Thank you for the reports and I understand the basic idea but what I'd like to know is the final design of the proposal with components (modules) and their specifications, including further details of the hardware and software of each component.

I'll send the questions about the technical details but let me send my questions about the overall design of your proposal. I think the grand design is essential information when we review for the technical decision.

Figure 1 Block diagram of the SK GPS system

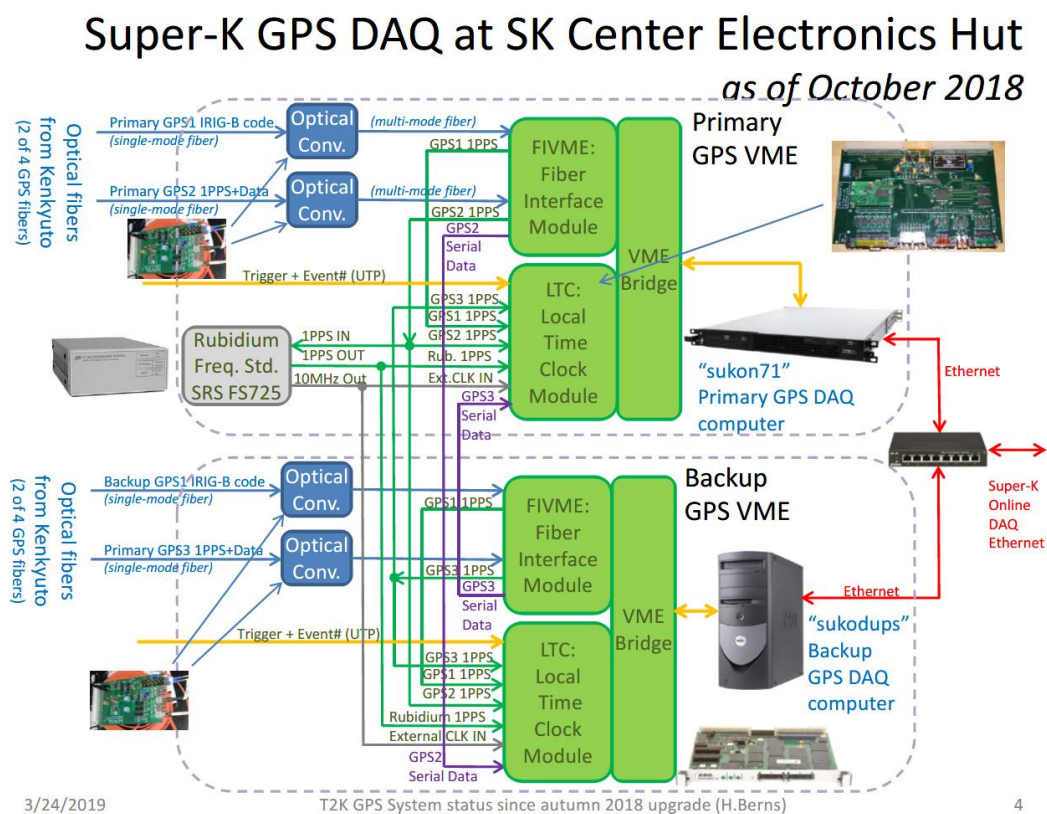
Q1) I'd like to see the block diagram like Figure 1.

There is a block diagrams in the proposal (Fig.3) but I'd like to see not the conceptual but the actual implementation as the "system".

The following is our initial idea based on our SK experience. At this moment, we don't send the UTC time stamp to each front-end board but record the timestamp at 60kHz, every time TDC is reset and one of the counters, so-called 32bit hardware (HW) counter, is incremented. (In Figure 1, this counter is expressed as "Event #", which is not the actual "event" number but the counter incremented every TDC reset @60kHz.)

Figure 2 Possible diagram for HK

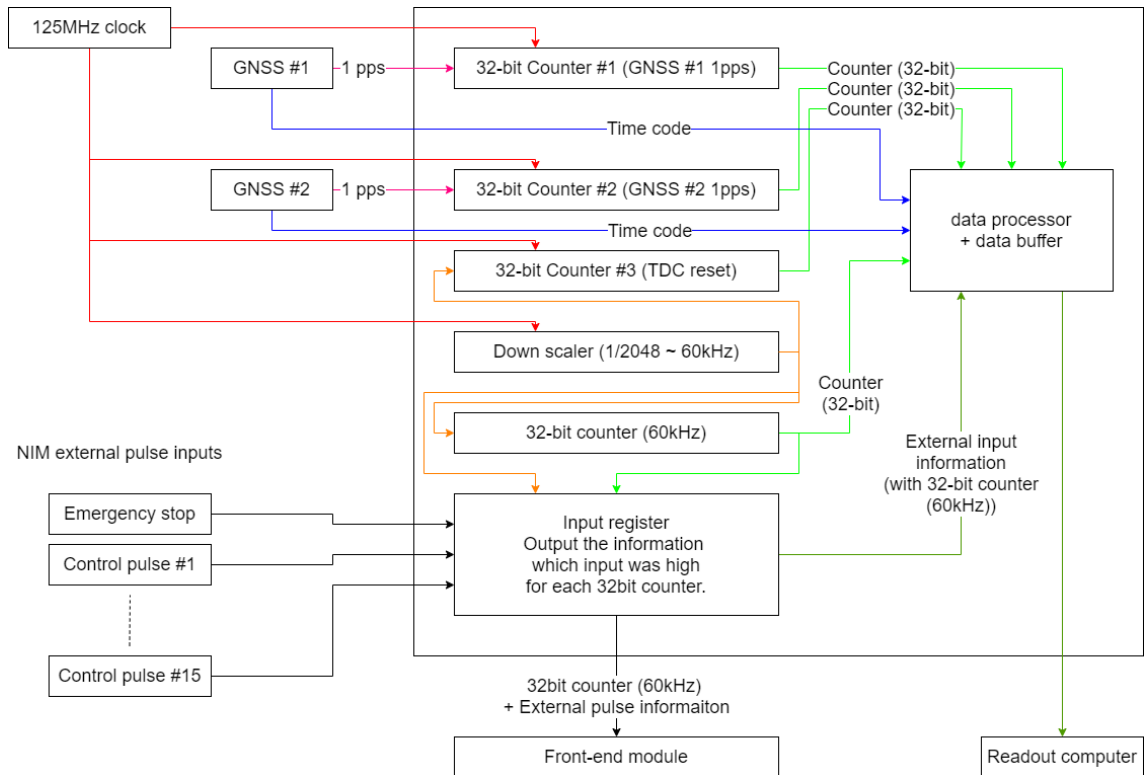
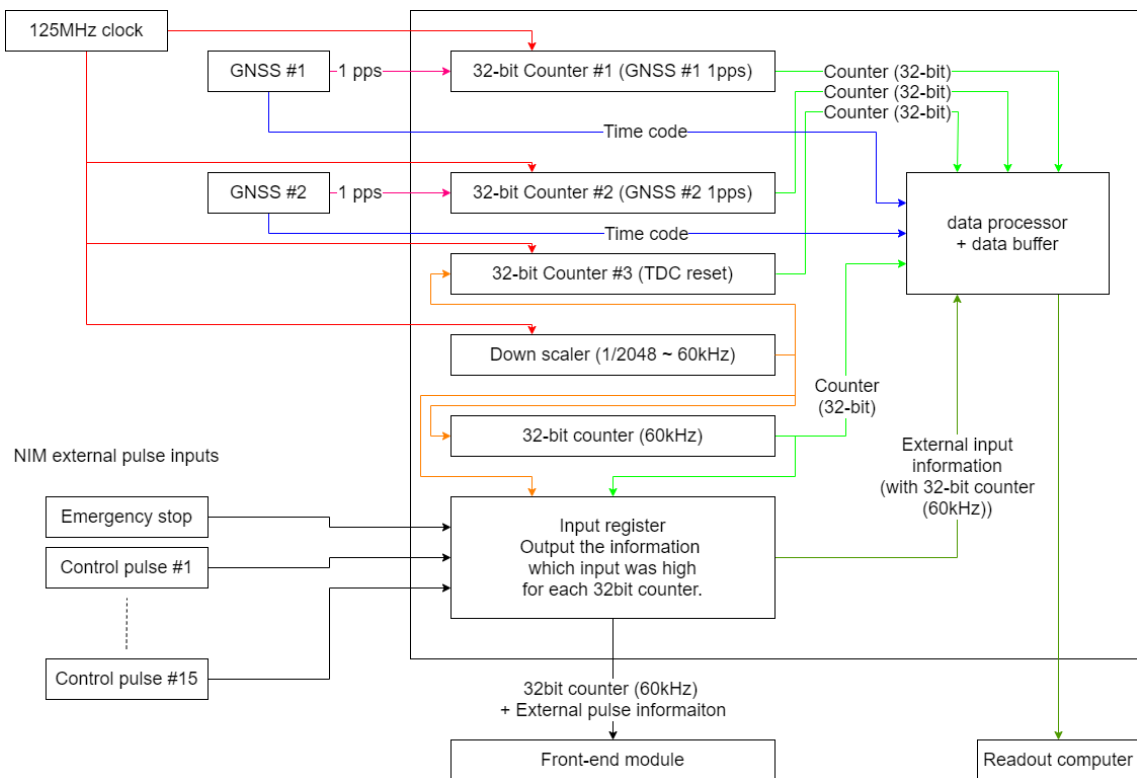
Based on our experience, I think it is sufficient to send a 32-bit counter, which counts up every 16384 ns (2048 cycles of 125 MHz clock), to each front-end boards for the 'global' synchronization just as we did in SK together with the external input signals. The possible diagram is shown in

Figure 2. In this case, the information sent to the front-end board via optical transmission are

- 1) 32-bit counter (60kHz) of TDC reset. This counter incremented every 16384 ns (= 8 x 2048 ~60kHz).
- 2) External input pulse information, i.e., bit pattern of external input.

- 1) 32-bit counter (60kHz) of TDC reset. This counter incremented every 16384 ns (= 8 x 2048 ~60kHz).
- 2) 32-bit counter value when the TDC reset occurs. This counter is incremented at 125MHz.
- 3) 32-bit counter value when the last 1pps pulse from GNSS #1 comes. This counter is incremented at 125MHz.
- 4) 32-bit counter value when the last 1pps pulse from GNSS #2 comes. This counter is incremented at 125MHz.
